Applicant:	Julie Salyers, J&B Builders, Inc.
Property Owner:	River 504 LLC
Location:	NE corner of S. 1 st & Prairie Streets
Purpose:	Feedback on a townhome development
Application:	Concept Plan
Public Hearing:	Not required
Zoning:	CBD-1 / PUD
Current Land Use:	Vacant
Comprehensive Plan:	Mixed Use

River 504 Townhomes

Suggested Action:	Provide feedback on the Concept Plan. Staff has provided questions Commissioners should use to guide their feedback to the applicant.
Staff Contact:	Ellen Johnson, Planner

1 SCHEMATIC SITE PLAN
 3/32" = 1'-0"

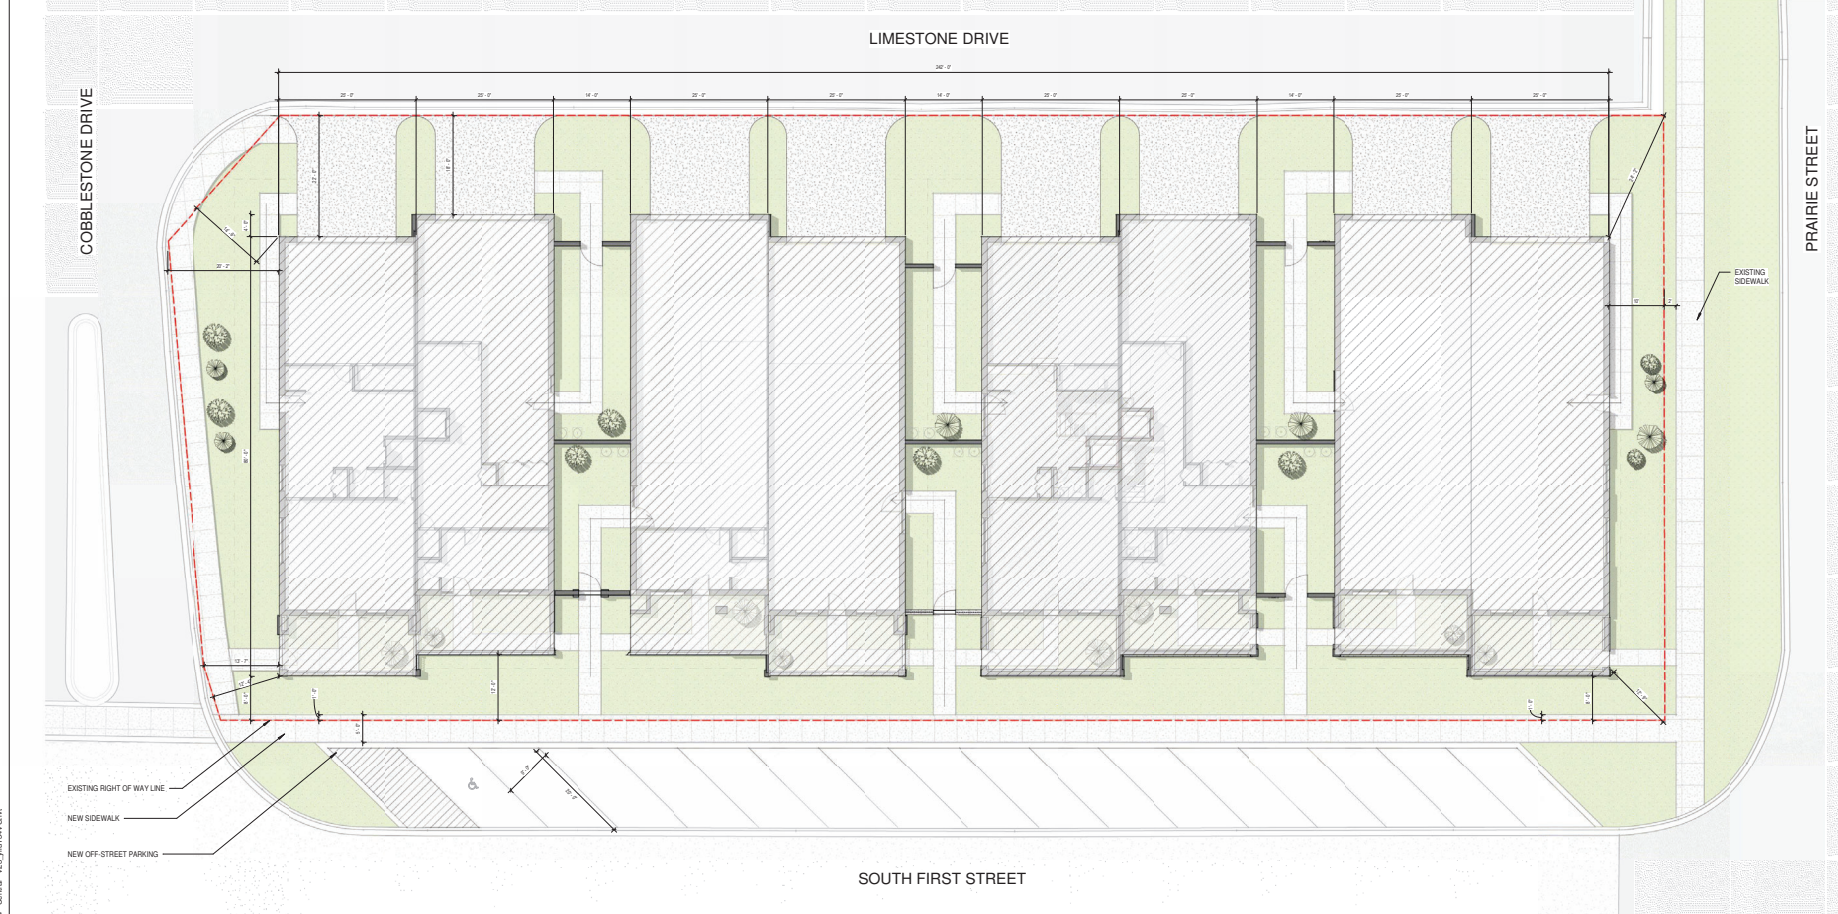
- ✓ Proposed driveways are 18 feet in length. A minimum driveway length of 20 feet is needed to allow for vehicle parking.
- ✓ Maximum building height in the underlying CBD-1 District is 50 ft., however the allowable building height for Milestone Row was reduced to 49 ft. under the 2005 PUD Ordinance. Proposed height is not indicated.
- ✓ The PUD Ordinance requires an additional 2 ft. right-of-way (ROW) dedication for 1st Street along the subject property. Once this ROW is dedicated, the proposed front setback is approx. 6 ft., which meets the 5 ft. setback requirement per the PUD.

The Concept Plan depicts attached garages accessed from the rear (east side) via driveways off Limestone Drive. Connection of Limestone Drive to Prairie Street is not proposed and is likely not permissible due to the proximity of the 1st & Prairie intersection.

- ✓ The proposed sidewalk along Cobblestone Drive should be shifted south to provide a parkway between the sidewalk and the street. A parkway width of at least 6 feet is suggested for consistency with the sidewalk/streetscape on the north side of Cobblestone Drive and elsewhere within Brownstone.

- ✓ Building foundation landscaping will be required in accordance with Section 17.26.080.
- ✓ Street trees will be required within the Cobblestone Drive parkway. Additional trees will be needed between driveways along Limestone Drive.
